**2016 EDITION OF THE  
LOS ANGELES REGION UNIFORM CODE PROGRAM**

**RECOMMENDED CODE AMENDMENTS TO THE  
2016 EDITION OF THE CALIFORNIA BUILDING CODE,  
CALIFORNIA RESIDENTIAL CODE, AND  
CALIFORNIA GREEN BUILDING STANDARDS CODE**

**ICC LOS ANGELES BASIN CHAPTER'S  
GREEN AND SUSTAINABILITY COMMITTEE  
STRUCTURAL COMMITTEE**

Final Version: August 5, 2016  
Updated Version: August 23, 2016

**FIGURE 2308.6.5.2**  
**PORTAL FRAME WITH HOLD-DOWNS (PFH)**

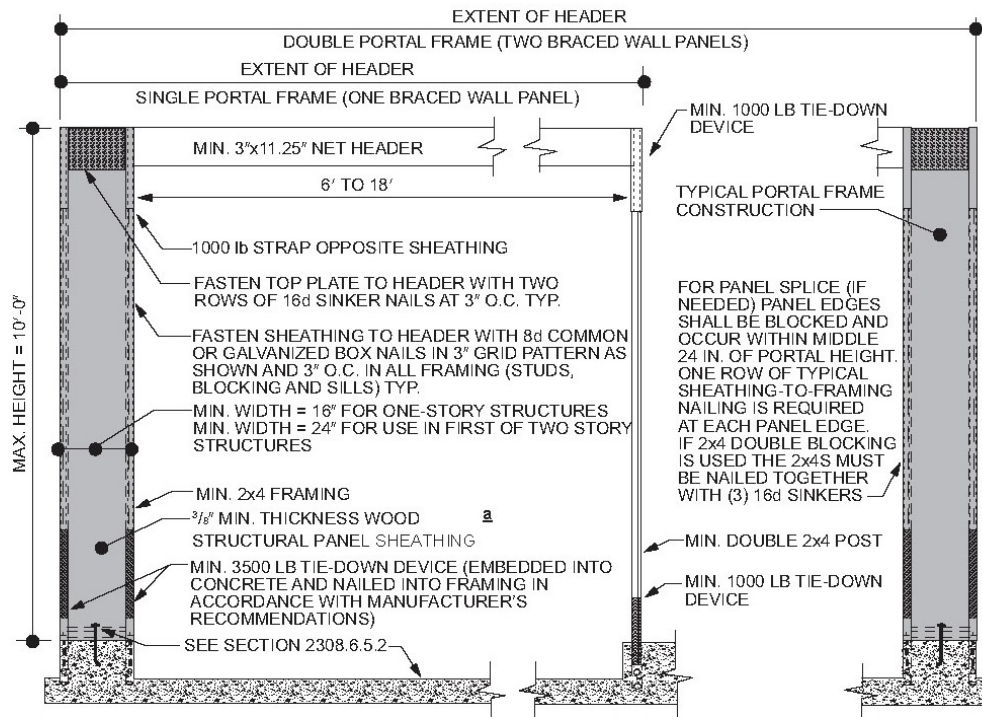
**2308.6.5.2 Portal frame with hold-downs (PFH).** A PFH shall be constructed in accordance with this section and Figure 2308.6.5.2. The adjacent door or window opening shall have a full-length header.

In one-story buildings, each panel shall have a length of not less than 16 inches (406 mm) and a height of not more than 10 feet (3048 mm). Each panel shall be sheathed on one face with a single layer of 3/8-inch (9.5 mm) minimum-thickness wood structural panel sheathing nailed with 8d common or galvanized box nails in accordance with Figure 2308.6.5.2. For structures assigned to Seismic Design Category D or E, each panel shall be sheathed on one face with 15/32-inch-minimum-thickness (11.9 mm) wood structural panel sheathing nailed with 8d common nails spaced 3 inches on panel edges, 3 inches at intermediate supports and in accordance with Figure 2308.6.5.2. The wood structural panel sheathing shall extend up over the solid sawn or glued-laminated header and shall be nailed in accordance with Figure 2308.6.5.2. A built-up header consisting of at least two 2-inch by 12-inch (51 mm by 305 mm) boards, fastened in accordance with Item 24 of Table 2304.10.1 shall be permitted to be used. A spacer, if used, shall be placed on the side of the built-up beam opposite the wood structural panel sheathing. The header shall extend between the inside faces of the first full-length outer studs of each panel. The clear span of the header between the inner studs of each panel shall be not less than 6 feet (1829 mm) and not more than 18 feet (5486 mm) in length. A strap with an uplift capacity of not less than 1,000 pounds (4,400 N) shall fasten the header to the inner studs opposite the sheathing. One anchor bolt not less than 5/8 inch (15.9 mm) diameter and installed in accordance with Section 2308.3.1 shall be provided in the center of each sill plate. The studs at each end of the panel shall have a hold-down device fastened to the foundation with an uplift capacity of not less than 3,500 pounds (15 570 N).

Where a panel is located on one side of the opening, the header shall extend between the inside face of the first full-length stud of the panel and the bearing studs at the other end of the opening. A strap with an uplift capacity of not less than 1,000 pounds (4400 N) shall fasten the header to the bearing studs. The bearing studs shall also have a hold-down device fastened to the foundation with an uplift capacity of not less than 1,000 pounds (4400 N). The hold-down devices shall be an embedded strap type, installed in accordance with the manufacturer's recommendations. The PFH panels shall be supported directly on a foundation that is continuous across the entire length of the braced wall line. This foundation shall be reinforced with not less than one No. 4 bar top and bottom. Where the continuous foundation is required to have a depth greater than 12 inches (305 mm), a minimum 12-inch by 12-inch (305 mm by 305 mm) continuous footing ~~or turned-down slab edge~~ is permitted at door openings in the braced wall line. This continuous footing ~~or turned-down slab edge~~ shall be reinforced with not less than one No. 4 bar top and bottom. This reinforcement shall be lapped not less than ~~15 24~~ inches (~~381 610~~ mm) with the reinforcement required in the continuous foundation located directly under the braced wall line.

Where a PFH is installed at the first story of two-story buildings, each panel shall have a length of not less than 24 inches (610 mm).

FIGURE R602.10.6.1  
METHOD ABW—ALTERNATE BRACED WALL PANEL

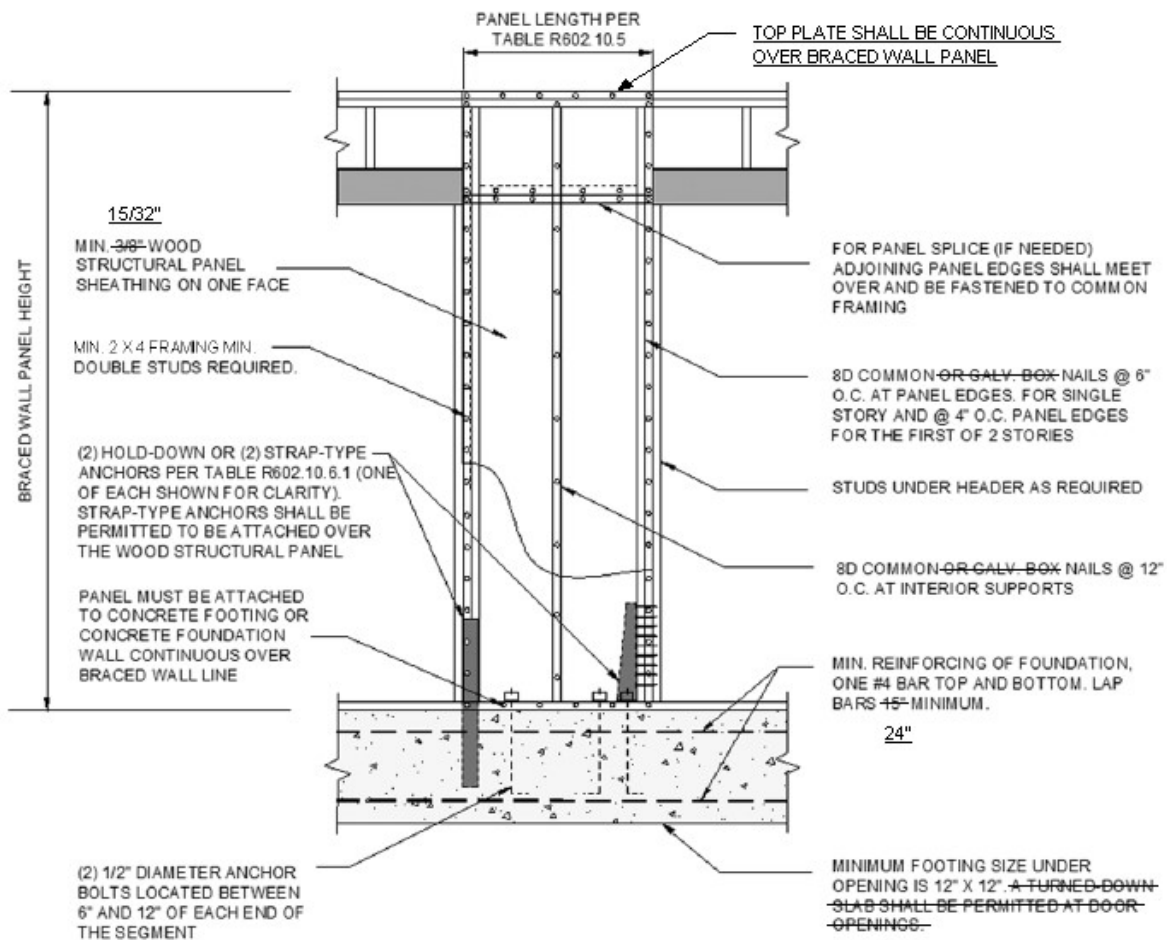
2016 LARUCP R6-05. Figure R602.10.6.1 of the 2016 Edition of the California Residential Code is amended to read as follows:

3/8" thick 3 ply-plywood shear walls experienced many failures during the Northridge Earthquake. Box nails were observed to cause massive and multiple failures of the typical 3/8" thick 3-ply plywood during the Northridge Earthquake. This proposed amendment specifies minimum sheathing thickness, nail size and spacing so as to provide a uniform standard of construction for designers and buildings to follow. This is intended to improve the performance level of buildings and structures that are subject to the higher seismic demands and reduce and limit potential damages to property. This proposed amendment reflects the recommendations by the Structural Engineers Association of Southern California (SEAOSC) and the Los Angeles City Joint Task Force that investigated the poor performance observed in 1994 Northridge Earthquake. This proposed amendment is a continuation of an amendment adopted during the previous code adoption cycle.
